From: Harrison Grace
Sent: 3/07/2024 11:23:21 PM
To: Council Northernbeaches Mailbox; Reeve Cocks
Cc: Kathleen Heath
Subject: TRIMMED: Re: Objection to Development Application DA2024/0179 for alterations and additions to a semi-detached dwelling at 30 George St Manly NSW 2095
Attachments: SecondObjection_DA2024_0179_HGrace_KHeath_v01.pdf;

Re: Objection to Development Application DA2024/0179 for alterations and additions to a semi-detached dwelling at 30 George St Manly NSW 2095

We, Harrison Grace and Kathleen Heath, the registered proprietors of the land comprising Lot 1 in DP 556938 situated at 32 George St Manly, maintain our objection to DA2024/0179 (**Development Application**) for alterations and additions to a semi-detached dwelling at 30 George St Manly (**Site**) as amended on 7 June 2024 for the reasons that follow.

Figure 1: Illustration of how the bulk of the development could have been more sensitively sited to avoid view impacts without adversely impacting the presentation to the proposed development street

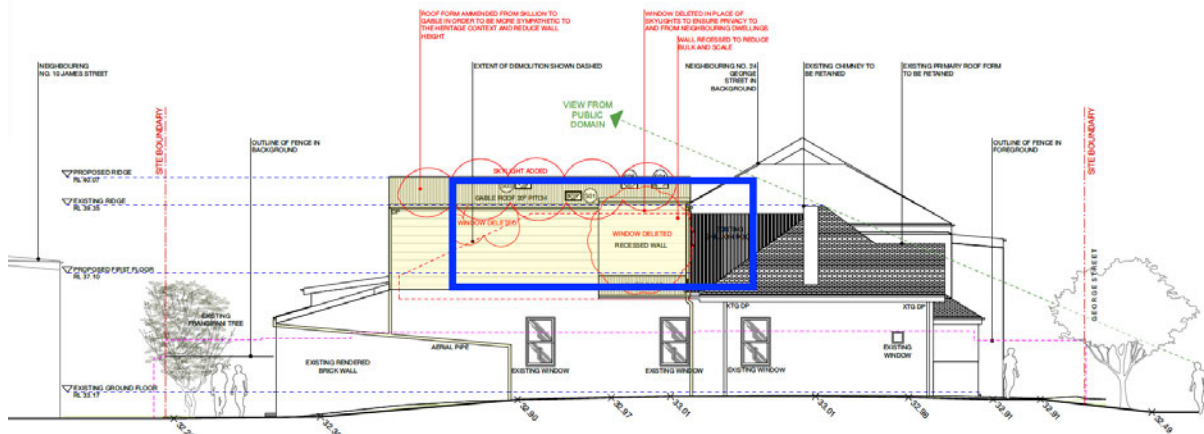
- 2.3.9. Moreover, the applicant has not considered whether any of the proposed first-floor addition could be located in the existing roof space contrary to cl 4.1.7 b) of the MDCP. A design change that made use of the existing roof space would alleviate the impacts on the views enjoyed from our property without detracting from the aesthetic and heritage values of the façade.

- 2.3.10. The only design change the applicant has considered is an increased setback. In the absence of any assessment of any meaningful design changes or alternatives, the Council could not be satisfied that a more skilful design would not reduce the impact on views whilst providing the applicant with the same development potential and amenity.
